Response to NRC Review Questions

LaCrosse Boiling Water Reactor
Dairyland Power Cooperative
Genoa, Wisconsin 54632

Re: Response to NRC Review Questions

We are submitting ten copies of the report "Response to NRC Review Questions, Seismic Hazard and Liquefaction Potential at LACBWR Site, near Genoa, Vernon County, Wisconsin" for your use. This report contains answers to all the questions raised by the Nuclear Regulatory Commission (NRC) in their letter of April 25, 1980, to Dairyland Power Cooperative (DPC).

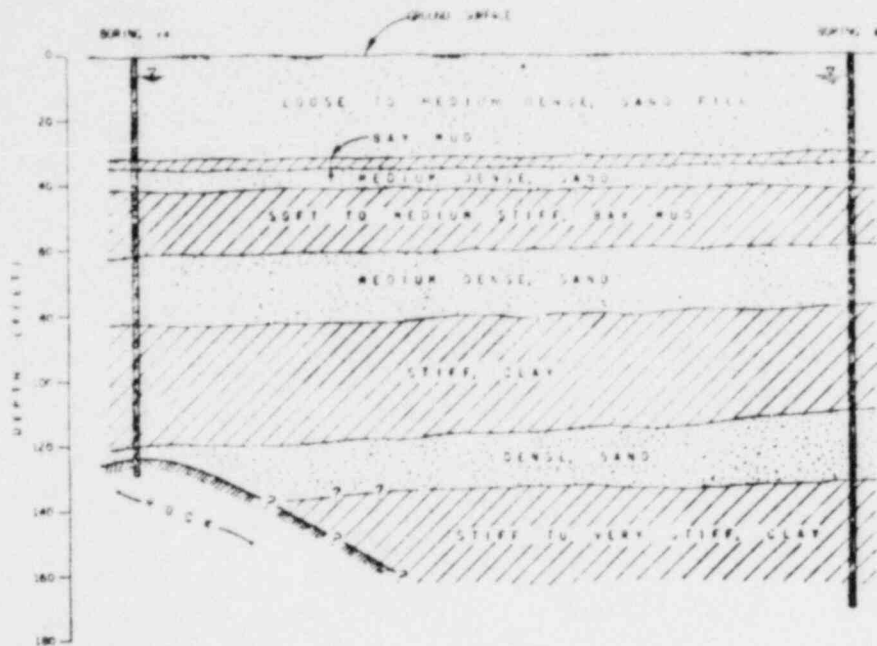
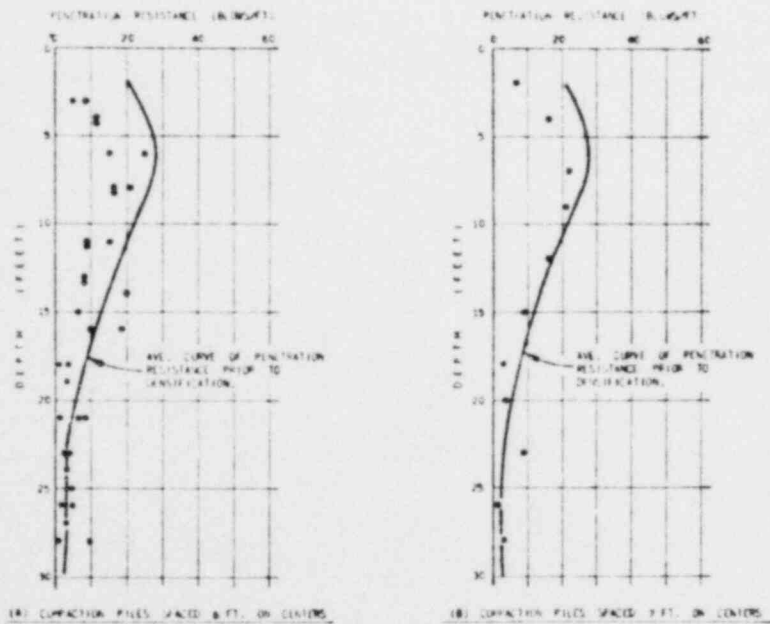
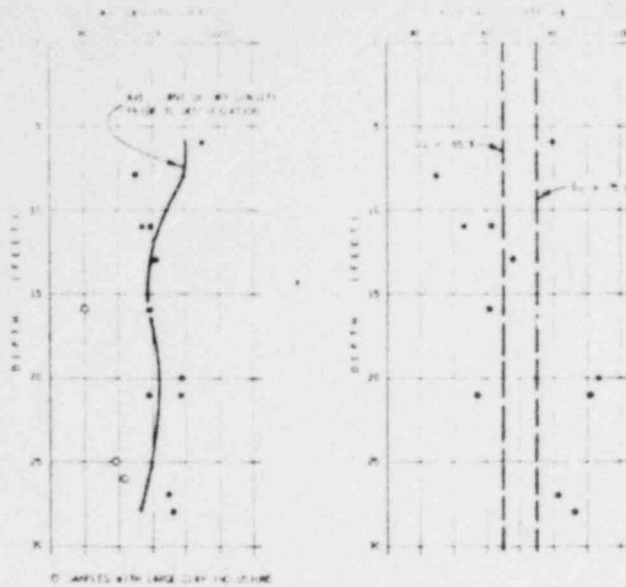
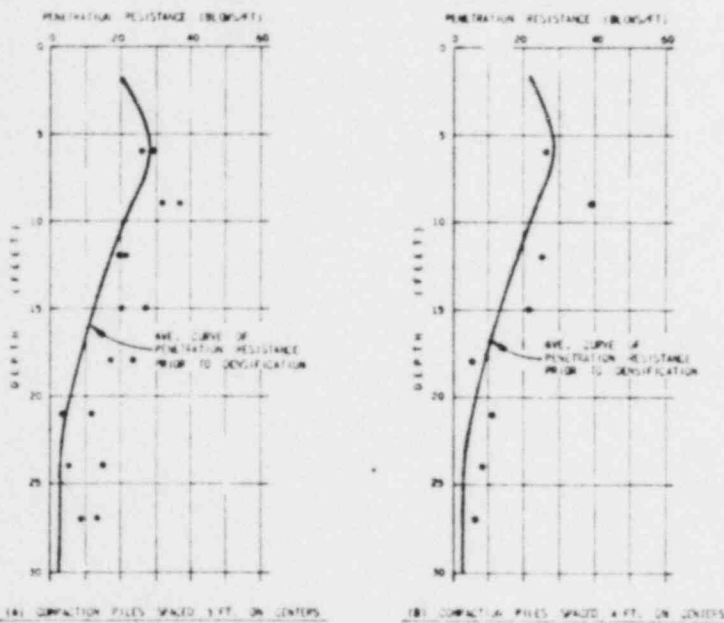
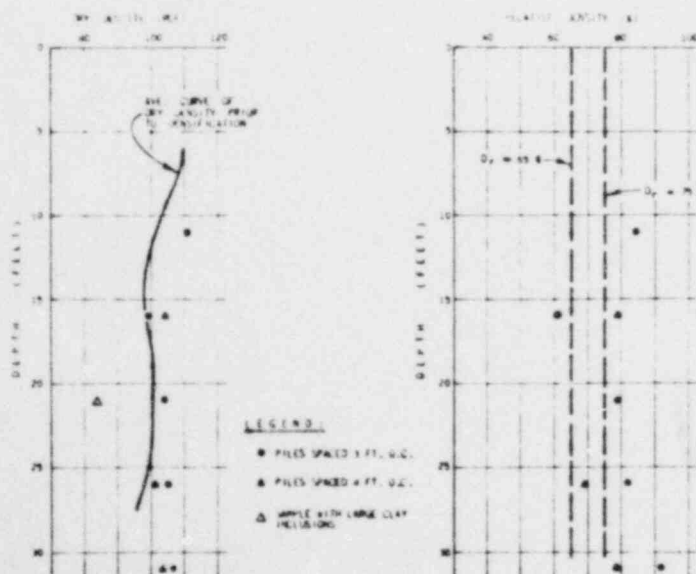
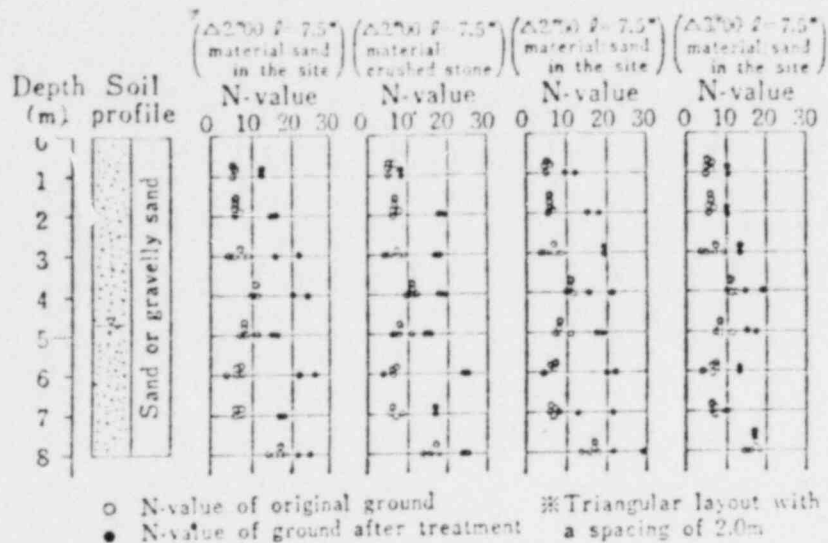
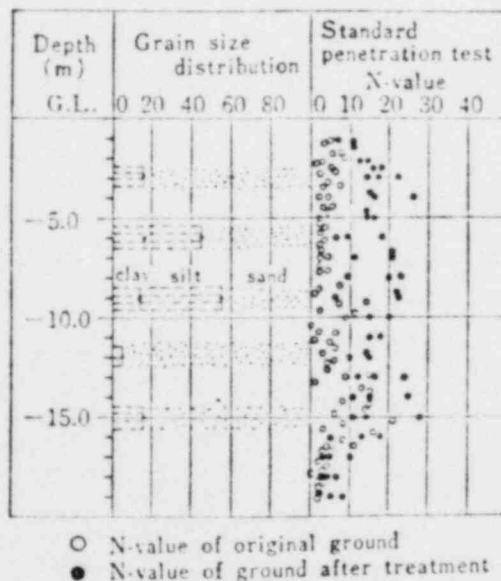
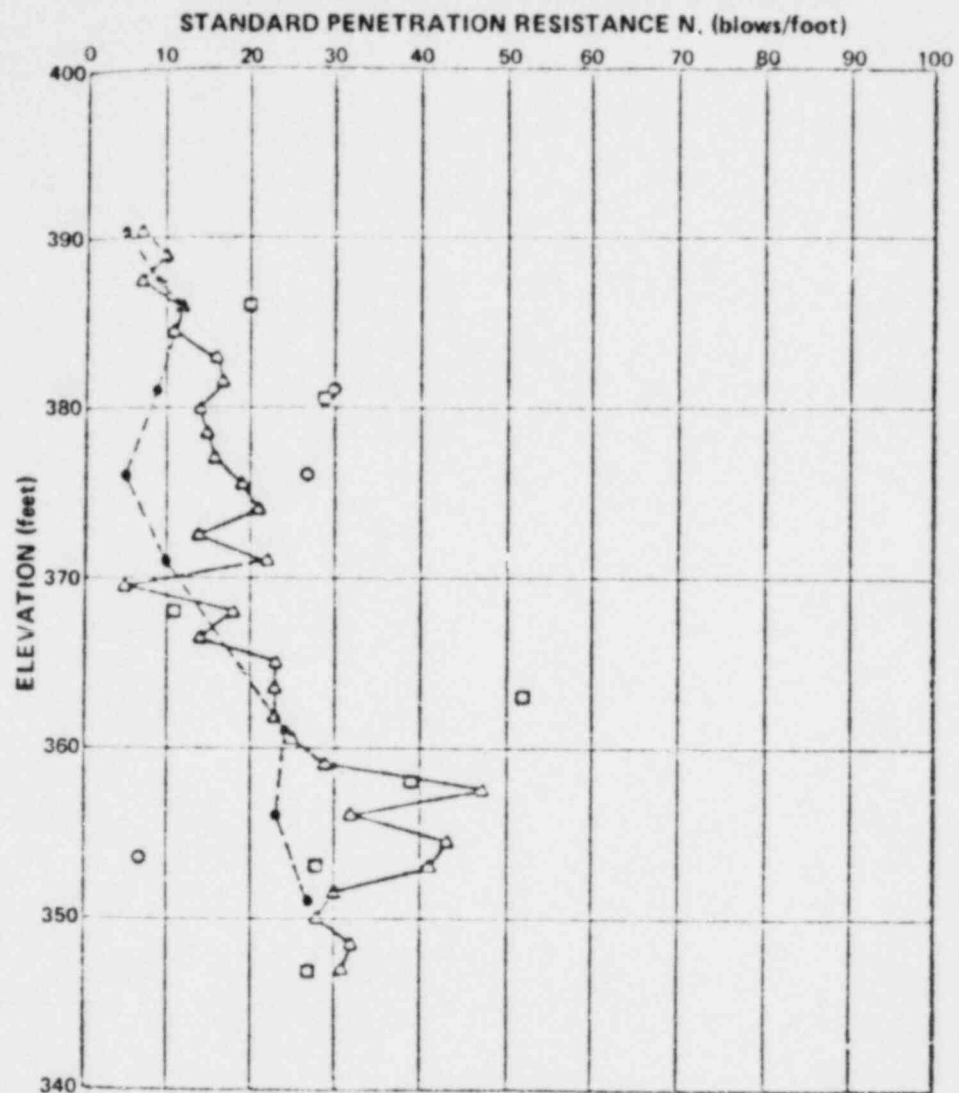
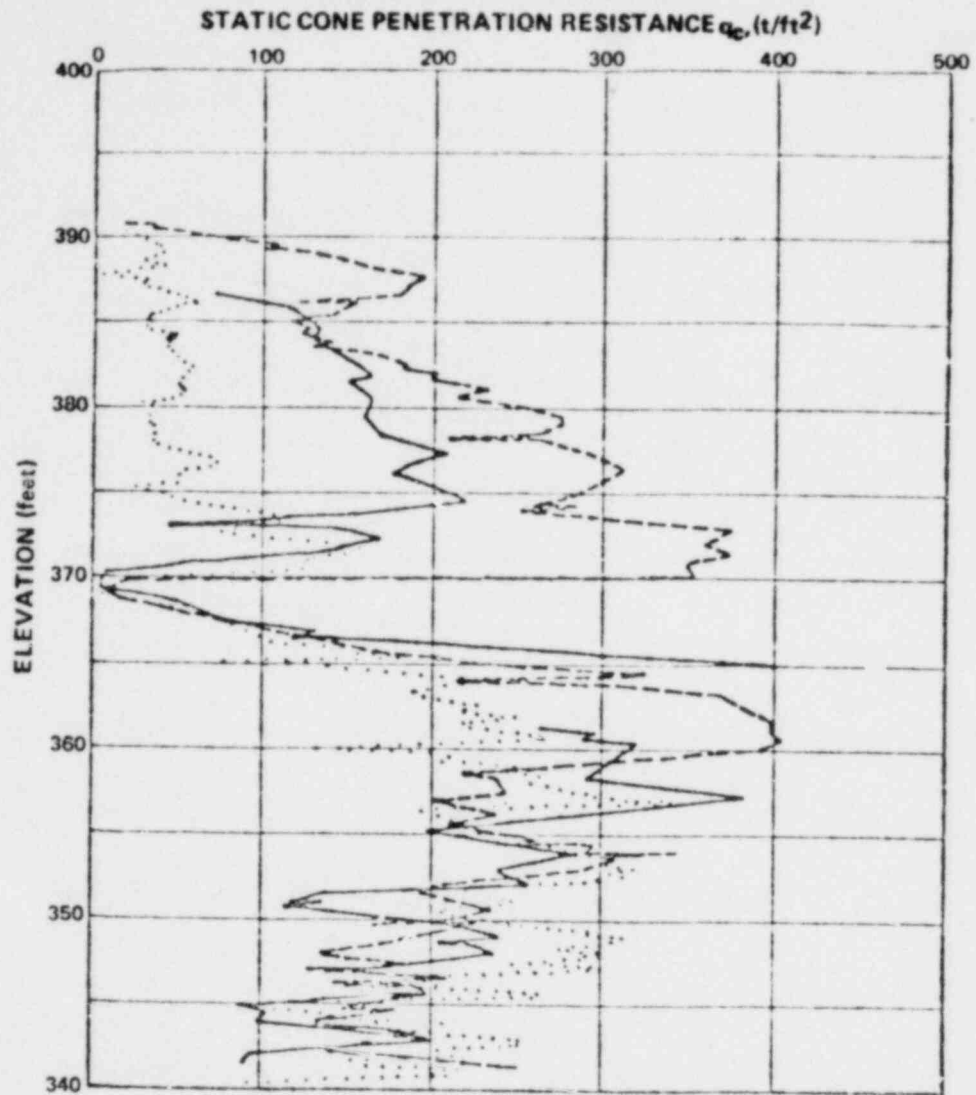
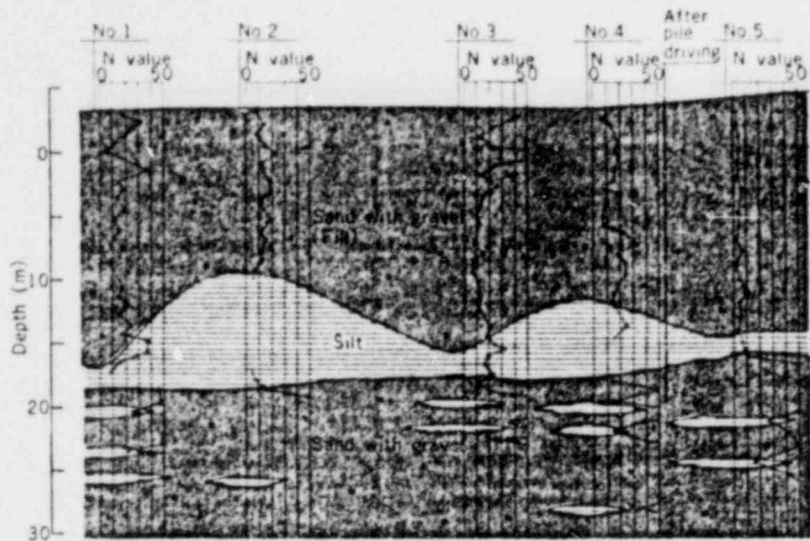
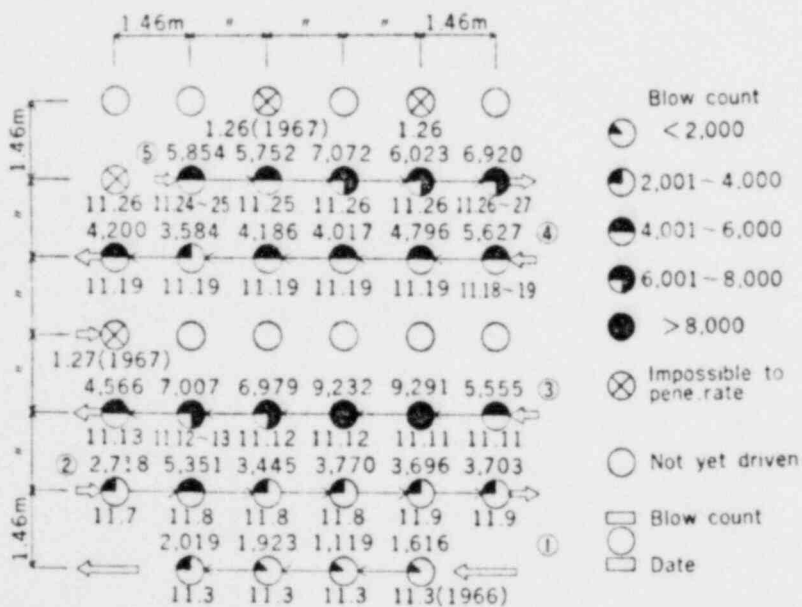
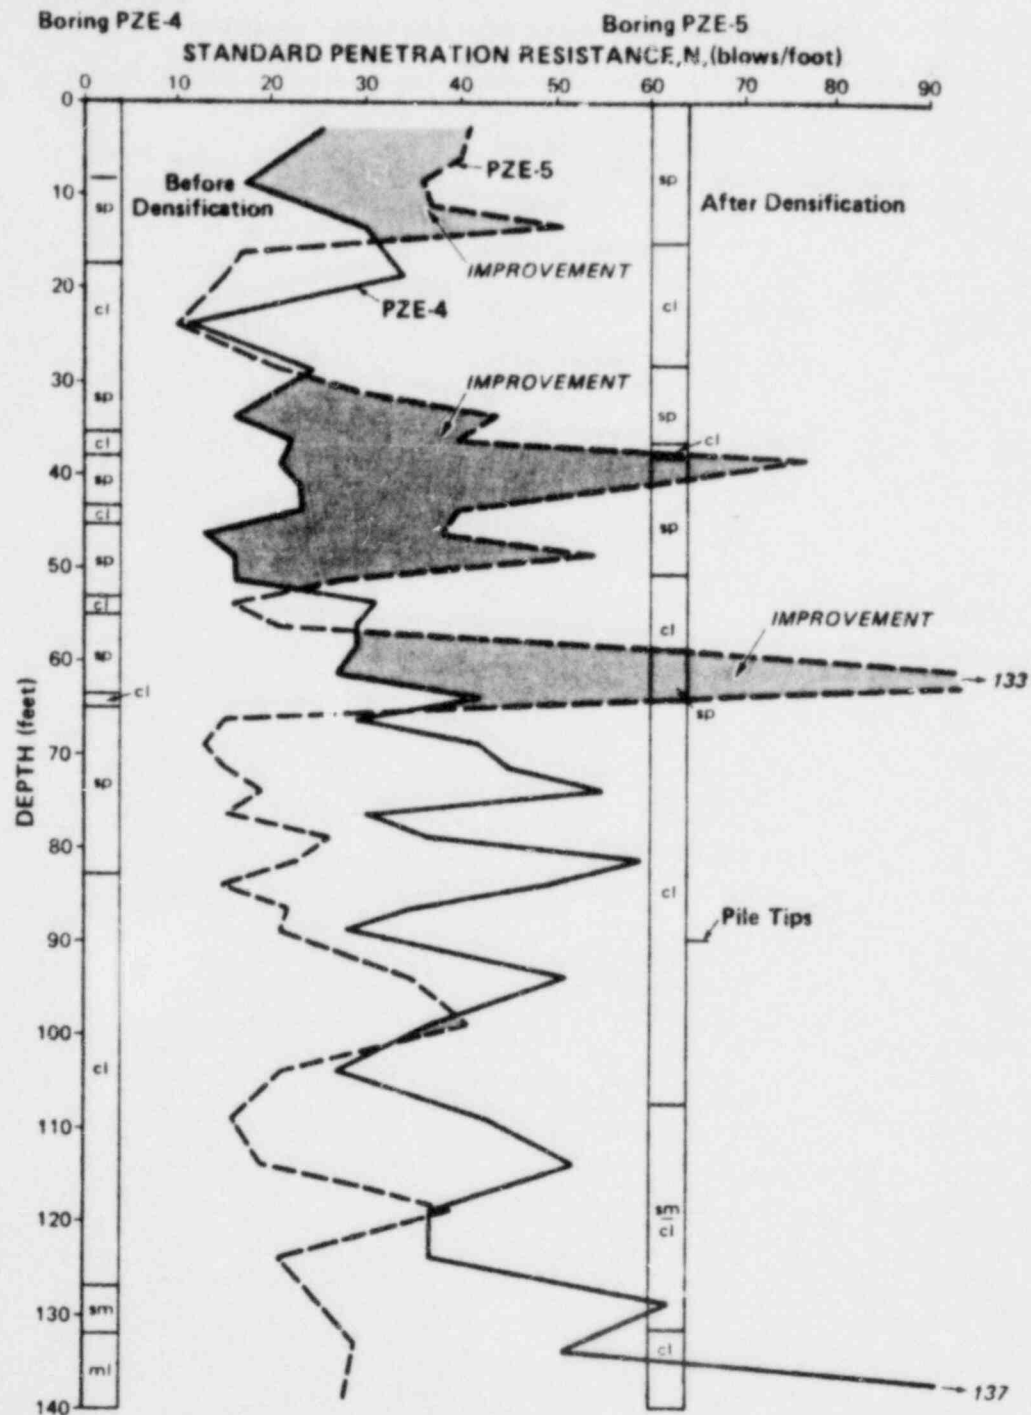
Question 2b

In addition to the D&M project discussed in answering Question 2a, various other projects have been documented in which driving of piles resulted in increases of SPT blow counts. Brief descriptions of several such projects and data summarizing the blow count increases are presented in answer to Question 2b.

Treasure Island was constructed in the San Francisco Bay by hydraulically placing sand fill over dense sand and soft-to-medium stiff silty clay (see figure 2b-1-1). The 30 feet of loose-to-medium dense fill was composed of clean sands in the fine-to-medium sand size range. To densify the soil to increase the safety factor against liquefaction under a proposed office building, sand compaction piles were installed. The installation procedure required driving a 14-inch diameter, hollow steel mandrel to the required depth, filling the mandrel with sand, applying 100 pound/square inch air pressure to the top of the sand column, and withdrawing the false-bottomed mandrel. Piles initially were placed on 6- and 7-foot centers, and ultimately on 3- and 4-foot centers to obtain the specified 75-percent relative density.

Comparisons of standard penetration tests and densities before and after densification by compaction piles at the different spacings are presented in figures 2b-1-2 through 2b-1-5. These plots demonstrate that compaction piles were an effective means of achieving the required densification of the sand fill at this site.

Figure 2b-2-1 illustrates the soil profile and the increases in SPT blow counts after treatment by sand compaction piles at various spacings.

A silo constructed on fill at the seashore of Kobe was to be founded on pedestal (compaction) piles of 51-centimeter diameter on centers of 1.46 meters. However, driving of the piles became progressively more difficult as the driven casings displaced soil and increased densities and blow counts. Original SPT data and soil profile of the site appears in figure 2b-5-1, and the pile-driving sequence is shown in figure 2b-5-2.

A test program was carried out in 1978 at the site of the proposed Bailly Nuclear Generating Station in Indiana, to evaluate the densification effect of the driven piles. H-piles, 90 feet long, were driven close together in two rows separated by about 5 feet, with SPT borings drilled between the two rows before and after pile driving. Plots of the blow counts before and after driving appear in figure 2b-6-1, with substantial improvement occurring in the sand soils as a result of the pile driving. (It should be noted that the H-piles are not displacement piles, and if displacement piles were driven the densification effect would be more pronounced.)
